**Re: GE-Pittsfield/Housatonic River Site  
Former Oxbow Areas A and C (GECD410)  
Second Addendum to Final Removal Design/Removal Action Work Plan**

*Second Addendum to  
Final Removal Design/  
Removal Action Work Plan for  
Former Oxbow Areas A and C*

**General Electric Company  
Pittsfield, Massachusetts**

**April 2006**

**Revised Figure 7-1 (Proposed Travel  
Routes for Excavated Materials  
to the OPCAs)**

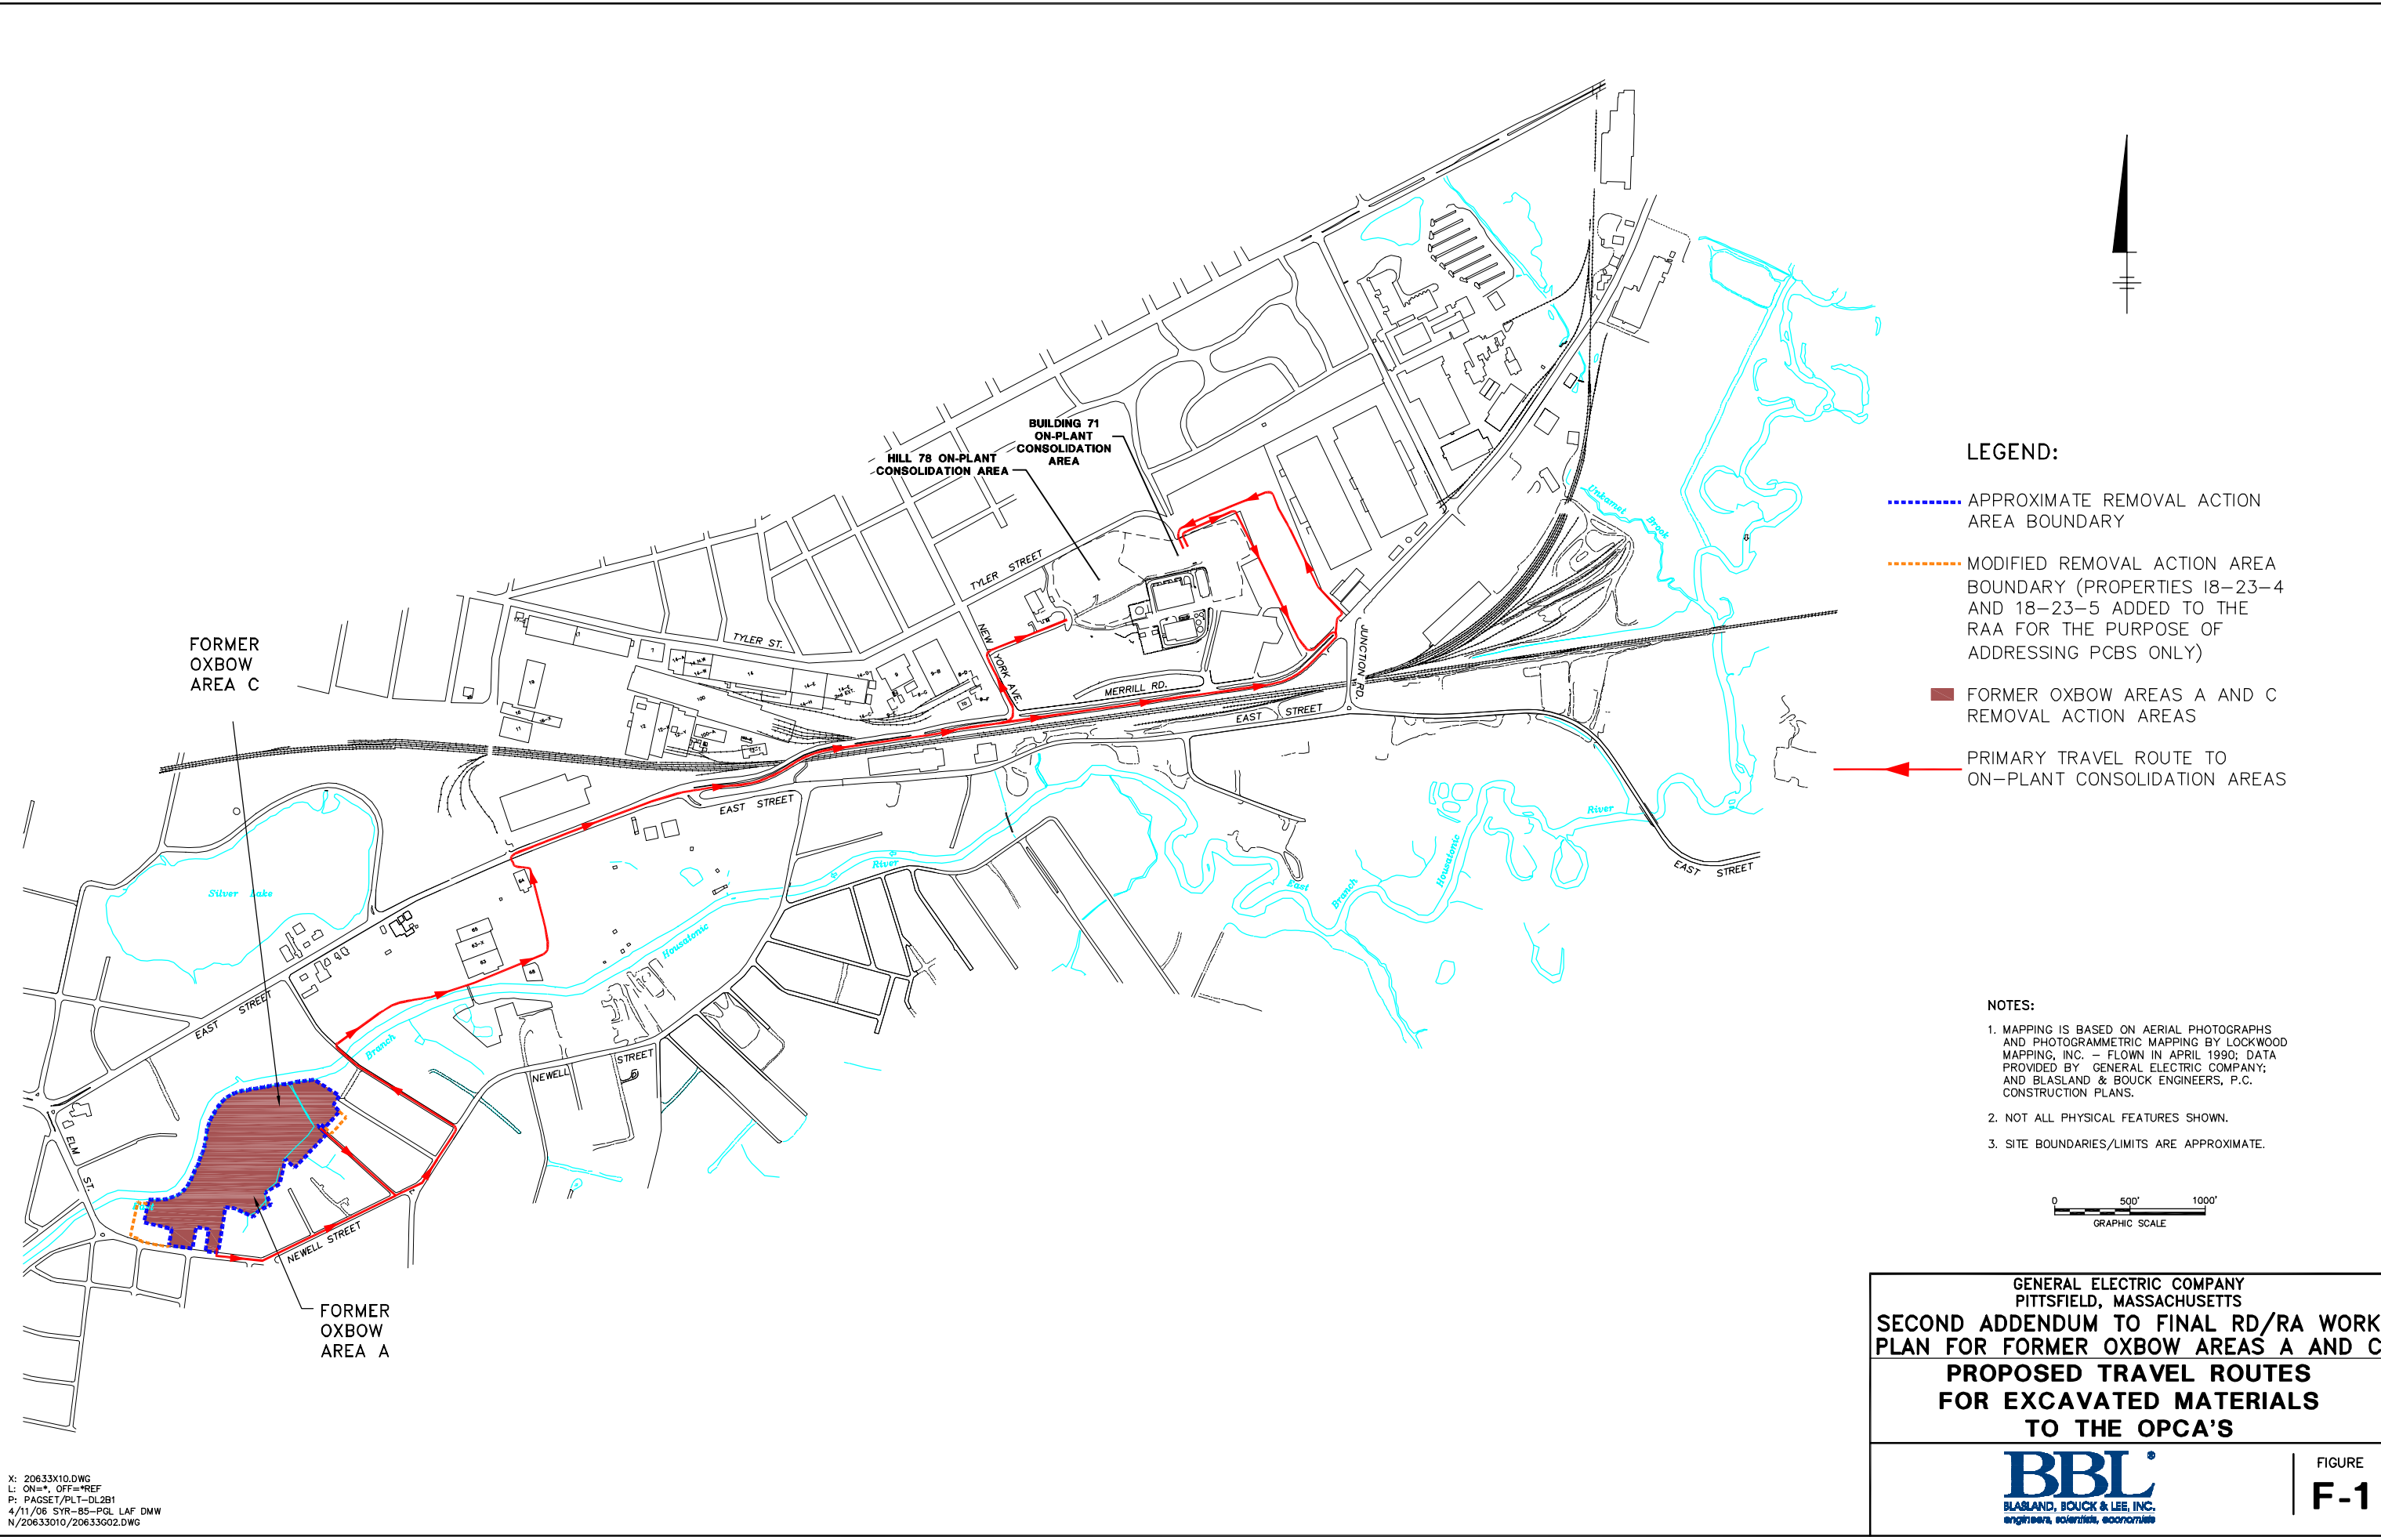
- GE has revised the truck traffic routes shown on Figure 7-1 of the Final Work Plan based on recent modifications to the operating procedures at the OPCAs. A revised Figure 7-1 of the Final Work Plan is included in Attachment F of this Second Work Plan Addendum. In addition, GE notes that the Department of Transportation (DOT) shipping description to be used on each Hazardous Materials Bill of Lading (BOL) has changed. The new DOT shipping description to be used on the BOL will be: “RQ, Polychlorinated biphenyls, mixture, 9, UN 3432, PG 111, RQ.”
